**EXPRESS TERMS
FOR
PROPOSED BUILDING STANDARDS
OF THE
OFFICE OF STATEWIDE HEALTH PLANNING AND DEVELOPMENT

REGARDING PROPOSED CHANGES TO
CALIFORNIA BUILDING CODE
CALIFORNIA CODE OF REGULATIONS, TITLE 24, PART 2**

**EXPRESS TERMS
Title 24, Part 2, Volume 1**

**PITCHED AND TAPERED CURVED BEAM****21. Sec. 5.4.1.2. Add a second paragraph:**

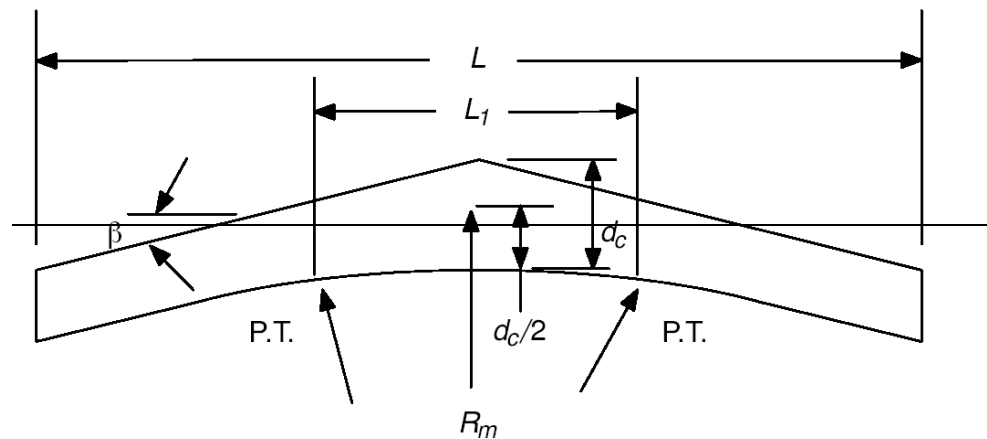
When the beam is loaded with a uniform load, K_r may be modified by multiplying by the reduction factor C_r as calculated by the following formula:

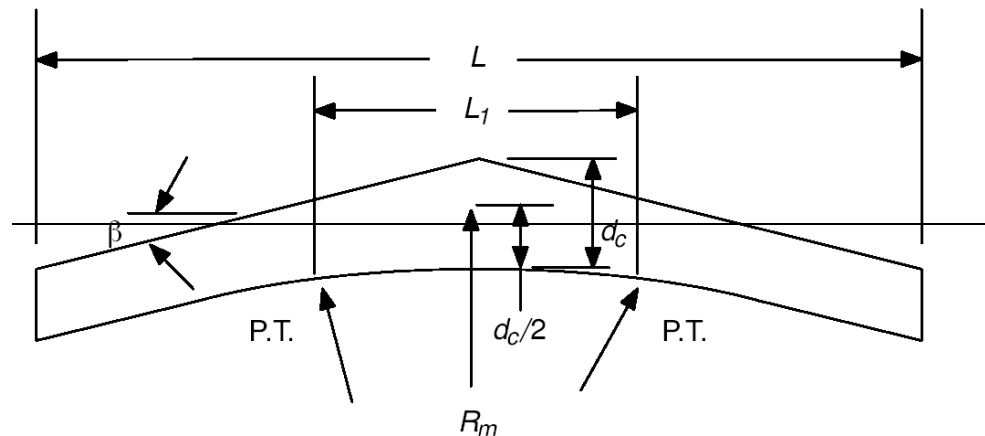
When the beam is loaded with a uniform load, K_r may be modified by multiplying by the reduction factor C_r as calculated by the following formula:
